Planning &
Environment

**STATE SIGNIFICANT DEVELOPMENT
ASSESSMENT REPORT:
*The University of Sydney Campus
Improvement Program Concept Proposal
(SSD 6123)***

Secretary's Environmental Assessment Report
Section 89H of the *Environmental Planning and
Assessment Act 1979*

January 2015

Figure 16: City Road Elevation

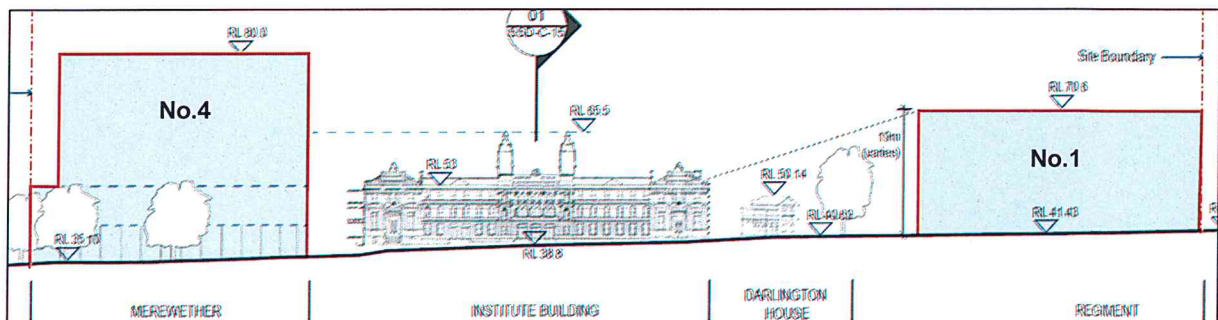
The proposed Regiment Building envelope footprint seeks to enhance the characteristics of the corner site and create an iconic gateway to the University precinct. The envelope footprint proposes zero boundary setbacks at the corner to its City Road and Darlington Road frontages, while the City Road setback then increases to provide a curtilage to the existing Institute Building.

The approved height of the Moore Theological College Building at RL 70.6 is the upper measurement of the rooftop plant enclosure, setback approximately six metres from the building façade, while the building design has a predominant parapet height of 24.8 m (RL 67.7). The Department is satisfied that the proposed RL 70.6 height of the Regiment Building envelope along its City Road frontage is satisfactory, though is of the opinion that a future assessment requirement is required to ensure any rooftop plant enclosures are appropriately setback from the street wall of the building to minimise bulk and scale impacts and provide greater consistency with the approved Moore Theological College Building opposite. Future development applications would also be required to satisfactorily demonstrate design excellence and appropriate built form massing, and be subject to design conditions and parameters associated with any approval given for the CIP.

Figure 17: Darlington Road Elevation

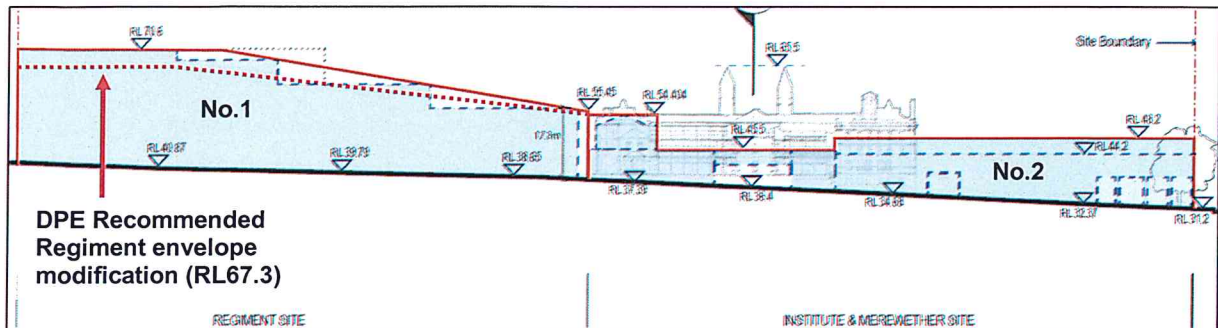
In response to the Darlington Road frontage, the Department supports the proposed tapering of the scale of the Regiment Building envelope's secondary frontage (see **Figure 17**). However, to ensure that potential bulk and scale streetscape impacts along this frontage are minimised, the RL 70.6 height should be restricted to the site's principle City Road frontage. Consequently, the secondary Darlington Road frontage should have a maximum height of RL 67.3 (approximately 25 m) that tapers to RL 55.45 (approximately 17 m) to provide a built form transition to adjacent residential development, thereby reducing potential amenity impacts (see **Figure 17**).

Figure 18: Butlin Avenue/Codrington Street Western Elevation

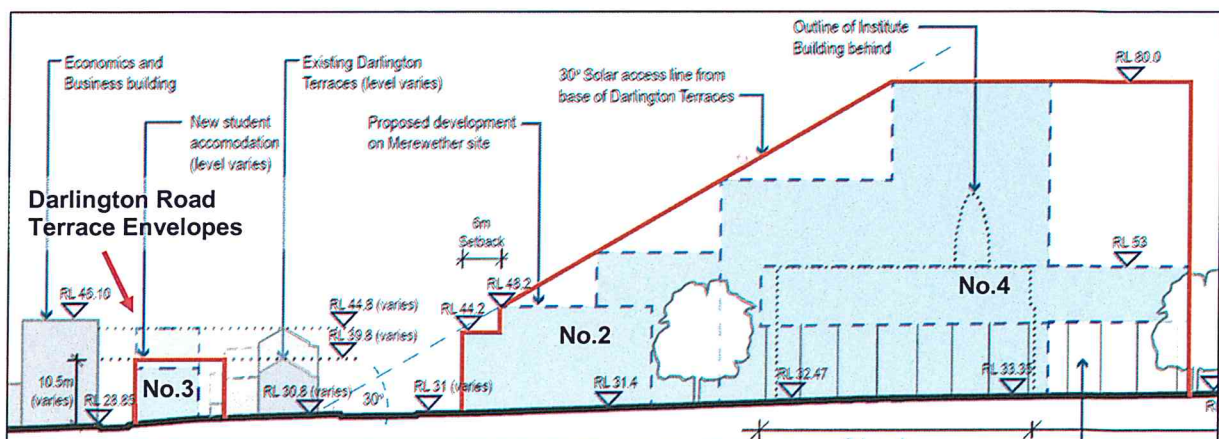
The Department raises no objections to the proposed scale and indicative building footprint of the revised Institute/Merewether Building envelopes (No.2 and No.4). The footprint provides a suitable curtilage to protect the heritage significance of the existing Institute Building and its proposed height provides a transition from Darlington Road through to the City Road (see **Figure 18**).

The amendments to the Merewether Building envelope, including a reduction in height and increased City Road setback, are supported by the Department and would allow prominent views to the Institute Building to be retained and creates an opportunity for a new vista from Maze Crescent (currently obscured by the existing Merewether Building) (see **Figure 8**).

The Department also notes that Council supports the revised envelope height and footprint, though advised that the building envelope should incorporate a podium and tower design, with a podium height of RL 53 consistent with the lowest parapet of the adjoining Institute Building. The Department also considers it appropriate that a future assessment requirement be imposed to ensure that a distinct podium and tower design is achieved. This is recommended within the Development Consent.

Figure 19: Darlington Road Terrace Envelopes

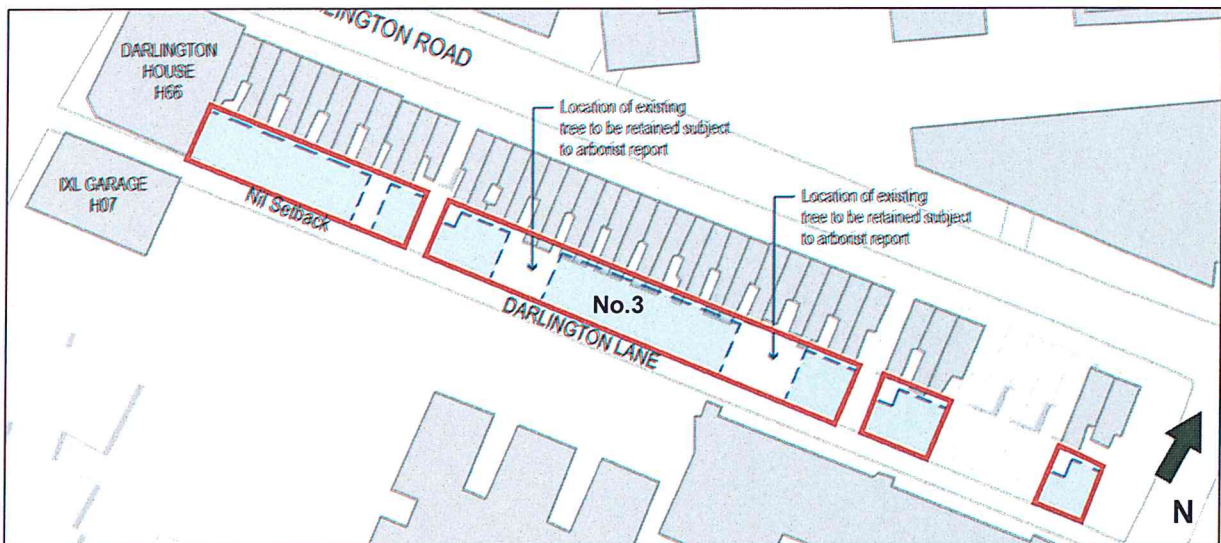
The Department is generally satisfied with the proposed footprint and scale of the building envelopes (see **Figure 19**), noting the applicant's commitment that future buildings additions would be subservient in scale to that of the existing terraces (see **Figure 20**). Future development within the rear yards of the terraces would therefore not be visible from Darlington Road, minimising potential impacts on the heritage significance of the terraces. The Department, though, recommends that a future assessment requirement be imposed to ensure that the design of the future built form at the Darlington Lane frontage expresses the existing terrace pattern and not be developed as one large building mass that extends along the length of the lane.

The applicant's proposed indicative built form also suggests a proposed setback (approximately four metres) between new built form and the rear of the existing terraces, no built form in sections adjacent to privately owned residential terraces to minimise potential amenity and privacy impacts, and the retention of existing mature vegetation at the rear of the terraces.

Figure 21: Butlin Avenue Eastern Elevation

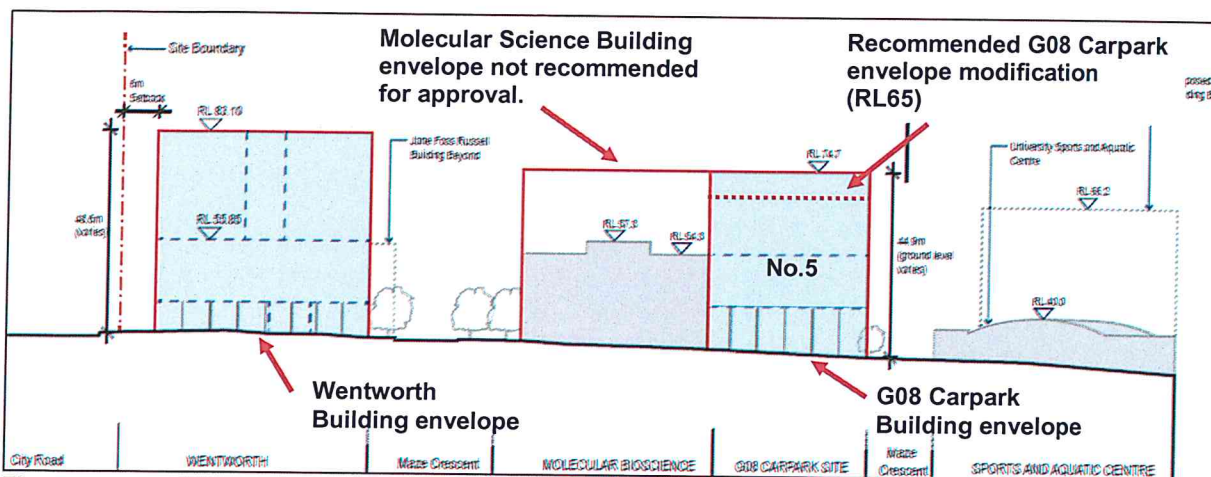
teaching and learning facilities, is out of context with the scale of existing development surrounding the site (Molecular Sciences Building at RL 57.3 and University of Sydney Sports and Aquatic Centre at RL 40) and provides a poor transition in scale to the proposed Wentworth Building (RL 80) (see **Figure 21**) and Merewether Building envelopes (RL 80).

In this regard, the Department considers that the building envelope should be restricted to RL 65, as also recommended by Council, and have a podium/tower design. Accordingly, the Department recommends a future assessment requirement to this effect. The recommended height will provide an improved transition from its immediate surroundings, such as the Abercrombie Precinct Redevelopment (RL 51.35 – 54.65), to future development proposed within the Merewether and Wentworth Building envelopes. Further, as no clear details of a building envelope have been provided regarding future proposed development above the existing Molecular Sciences Building adjacent to the G08 Carpark Building envelopes site, any approval of the CIP would not extend to the Molecular Sciences Building.

Figure 22: City Road Elevation

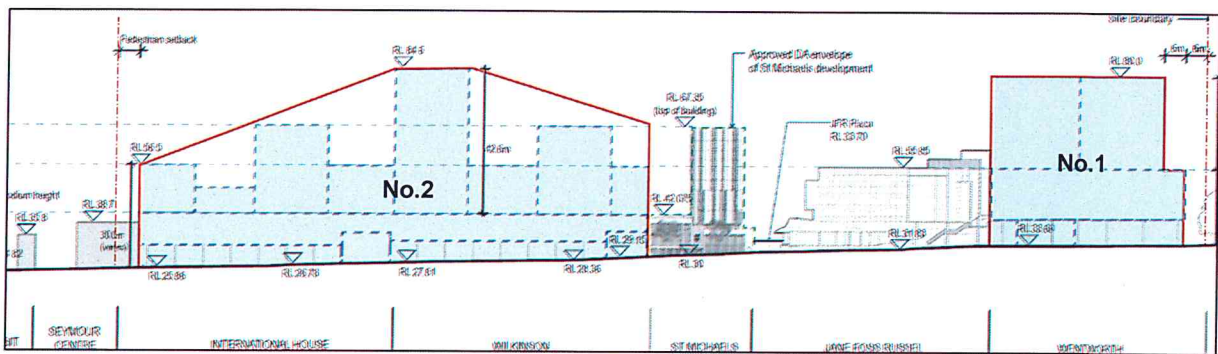
The proposed footprint, height and scale of the Wentworth building envelope is supported by the Department (see **Figure 22**). The proposed 3.1 m height reduction to RL 80 provides a consistent building envelope height with the Merewether Building envelope located opposite, providing a gateway to the Darlington Campus, while also providing a transition in scale down to the G08 Carpark Building envelope and surrounding Darlington Campus.

Notwithstanding the concerns raised by Council and agencies regarding the proposed demolition of International House, the proposed redevelopment of the proposed City Road Precinct was generally supported by Council and the agencies. In response to the concerns raised, the applicant's RtS and RtS supplementary submission retained the overall maximum height of the International/Wilkinson Building envelope at RL 84.6, though amended the envelope profile to provide a better transition in scale from the Seymour Centre to the east and the adjacent approved St Michael's development to the west. This was achieved by moving the maximum building envelope height to the centre of its footprint and reducing the height of its western edge to RL 67.35 (consistent with the adjacent St Michael's development), creating a more tapered building envelope profile (see **Figure 22**).

The applicant's amended International/Wilkinson Building envelope provides three indicative built forms consistent to or smaller than the approved St Michael's development at RL 67.35, and one larger indicative building form centrally located within the footprint at RL 84.6, approximately 17 metres taller. Council's City Road setback recommendation has not been adopted, however the applicant has advised that an allowance has been made for future built forms to incorporate a colonnade, which would effectively provide a wider footpath.

Existing development fronting City Road has generally been developed to the street edge, including the new St Michael's development (currently under construction). The proposed zero setback to City Road of the podium/tower design of the International/Wilkinson Building envelope would retain the established street wall, but provide improved pedestrian amenity via a future colonnade.

The amendments to the International/Wilkinson Building envelope are supported by the Department and provide an improved response to the precinct's immediate setting. They will ensure future built form is generally consistent with the scale of the St Michael's development, while offering an opportunity to develop a taller building form element to provide variation and interest in the City Road skyline. Furthermore, the indicative built form within the building envelope depicts a podium and tower design consistent with the adjoining St Michael's development, with tower forms separated and setback from the podium edges.

Figure 23: Shepherd Street Elevation – Chemical Engineering Building and Services Building Envelopes

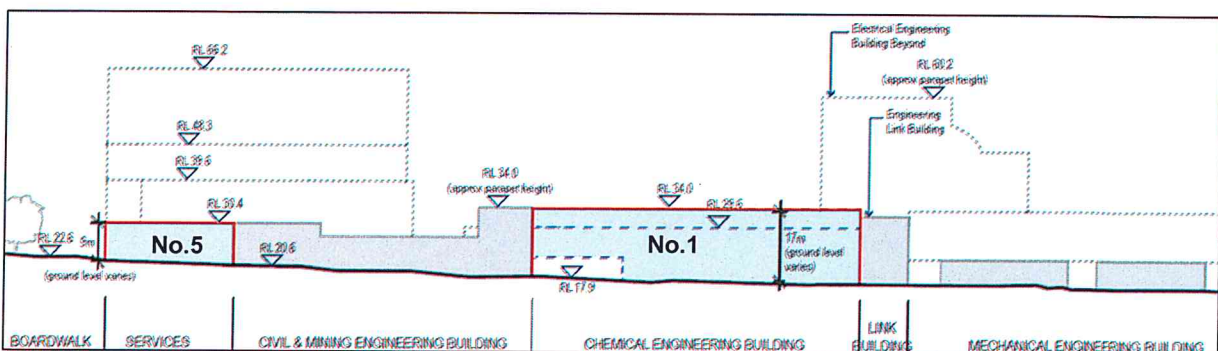
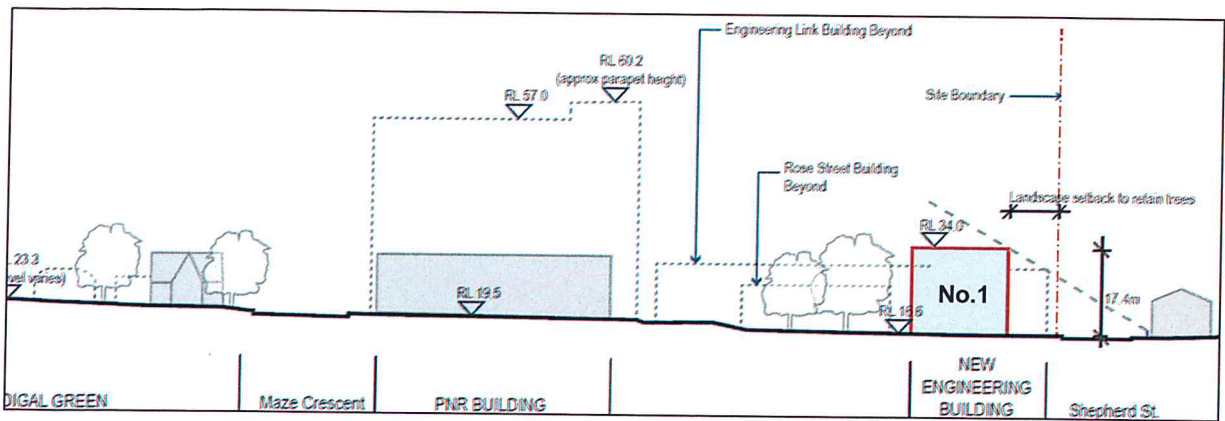
The applicant's RtS and RtS supplementary response proposed amendments to the layout of the Chemical Engineering Building envelope, with its footprint setback further into the site to enable the retention of a row of existing trees fronting Shepherd Street (see **Figures 23 and 24**) and its maximum height slightly increased from RL 33.6 to RL 34.

The Department is generally satisfied with the proposed scale and height of the building envelopes, in particular the building envelopes fronting Shepherd Street (No.1 and No.5), which propose a scale generally consistent with existing built form within the precinct. Their footprint layout and proposed heights are consistent with existing University development that fronts Shepherd Street and would not give rise to adverse amenity impacts.

Figure 25: University Boardwalk Northern Elevation

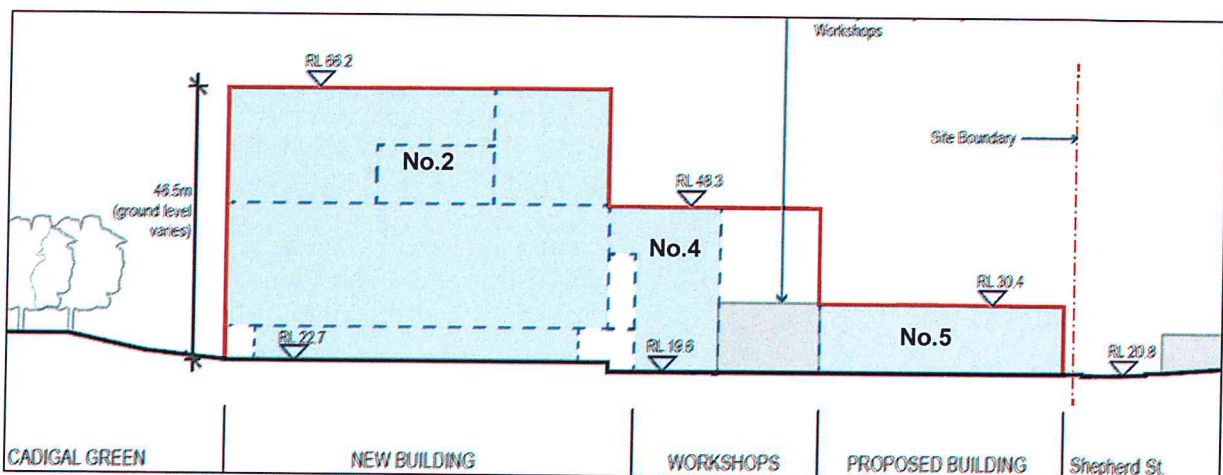
The Department had identified that the transition in height between the proposed lower scale building envelopes fronting Shepherd Street to the proposed larger building envelopes behind should be improved to minimise potential bulk and scale impacts on the surrounding lower scale development of the adjacent Darlington residential suburb. In response, the Workshop Building envelope height was amended and reduced by 17.9 metres from RL 66.3 to RL 48.3, providing a significant improvement to the transition in scale from Shepherd Street to the new proposed building envelope No.2 at RL 66.2 (see Figure 25).

The proposed amendments to the Workshop Building envelope are supported by the Department. The amendments provide for improved future built form outcomes and enable a more sympathetic interface with the adjoining residential properties on the opposite side of

Shepherd Street. In this regard, the stepped built form will provide a transition in scale and increased separation (approximately 80 metres) from the adjacent Shepherd Street residences to the precinct's largest building envelope (No.2) (see **Figure 25**). The amendments also provide a more balanced transition between the residential edge of the Darlington Campus to future larger scale development proposed within the Merewether and City Road Precincts.

Figure 28: Mid-Envelope Northern Section

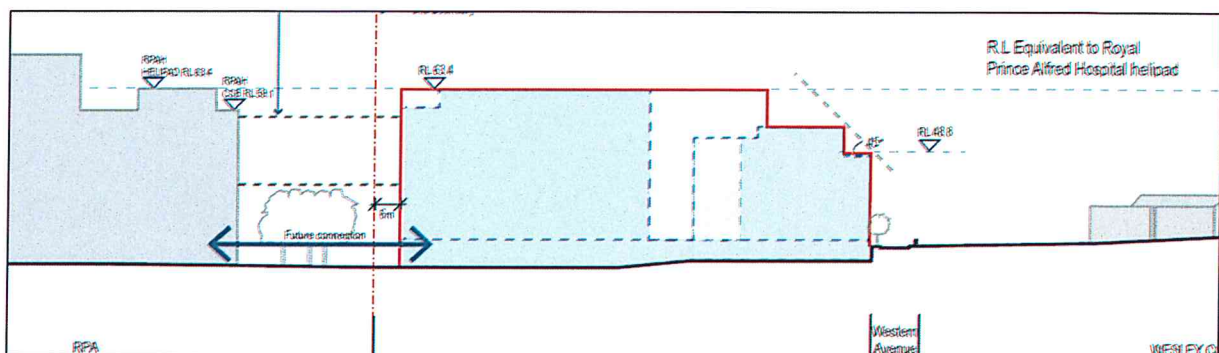
Prior to lodging its RtS, the applicant undertook further consultation with the adjoining residential colleges and the RPA Hospital to better inform their design response for the precinct, a summary of which is included within its RtS. In the RtS and RtS supplementary response, the configuration of the Health Precinct was amended to correctly align the building envelope's western boundary and amend its footprint to provide a minimum six metre setback to RPA Hospital. The maximum height of the building envelope was also reduced by 13.7 metres, from RL 77.1 to RL 63.4, to be consistent with the height of the adjoining RPA Hospital helipad (see **Figure 28**).

The amendments to the Health Precinct building envelope are supported by the Department, and will ensure future built form within the precinct provides a sympathetic response to the existing urban context, while not adversely constraining the development opportunities immediately adjacent to the precinct. The proposed amendments to the building envelope footprint to exclude the Bruce William Pavilion will also minimise impacts on the continued operations of existing businesses and will not restrict the ability for the potential future expansion of University Oval No.1 (not proposed in this application).

The tapered profile of the building envelope along its frontages within the University is supported by the Department, which will provide a transition to lower scale development adjacent, including St Andrew's College (Cadigal Lane), Wesley College, Wemen's College and University Oval No.1, and will also minimise potential overshadowing impacts.

The proposed six metre setback to RPA Hospital will assist in minimising potential bulk and scale impacts on the hospital, with the upper level of indicative built form also proposed to be stepped in from the building envelope footprint boundary. The applicant's RtS and RtS supplementary submission design response is considered to have satisfactorily addressed the key concerns raised. The Department also notes that a further submission was received from St Andrew's College that provides support for the revised scheme.

Figure 29: Parramatta Road Southern Elevation

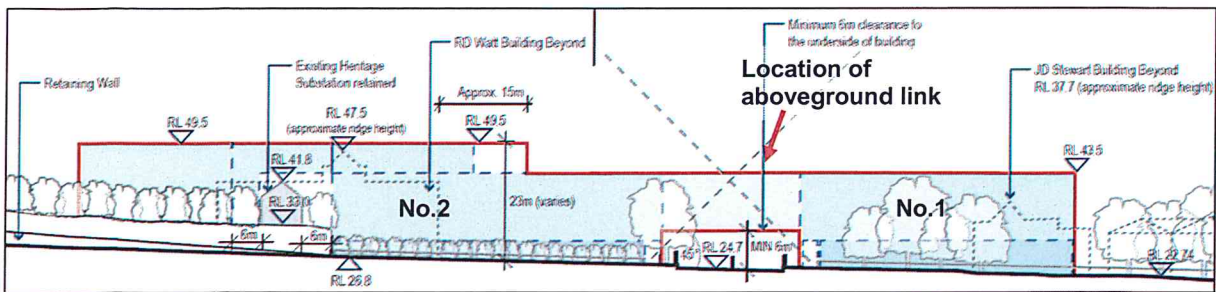
The Department supports the proposed enhancement of the Ross Street Gateway and celebration of the University's original Parramatta Road entrance. The proposed stepped scale and height of the Ross Street Building envelopes (No.1 and No.2) satisfactorily responds to the scale of existing topography (see **Figure 29**), which rises approximately nine metres from the Ross Street gates to the eastern edge of building envelope No.2 and surrounding development, both within and outside of the University's grounds (see **Figure 30**). Additionally, future built form within the proposed envelopes will benefit from existing mature vegetation along the University's Parramatta Road frontage that will aid in visually softening building bulk and mass.

The applicant also states it is envisaged that the above-ground link between the proposed Ross Street Building envelopes No.1 and No.2 (see **Figure 29**) would be designed as a lightweight/transparent structure that would provide accessibility between the future built forms either side of the Ross Street entrance, but also retain and frame views associated with the Western Avenue axis.

Figure 32: Concept Landscape Plan

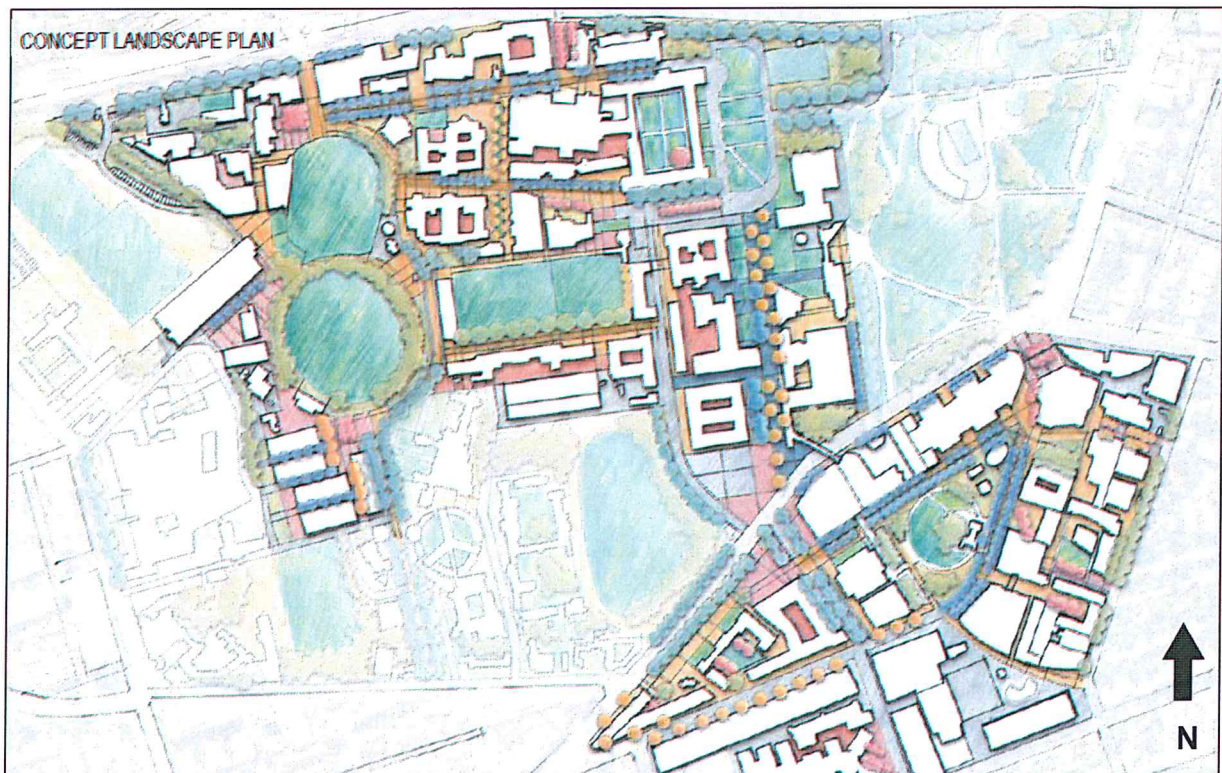
Council commented that the proposed precinct building envelopes conflicted with the proposed concept landscape plan, and that the success of the proposed landscaping relied on indicative building footprints. Concerns were also raised in public submissions regarding the potential impacts that future development would have on tree protection zones, opportunities for replacement canopy trees and mature vegetation.
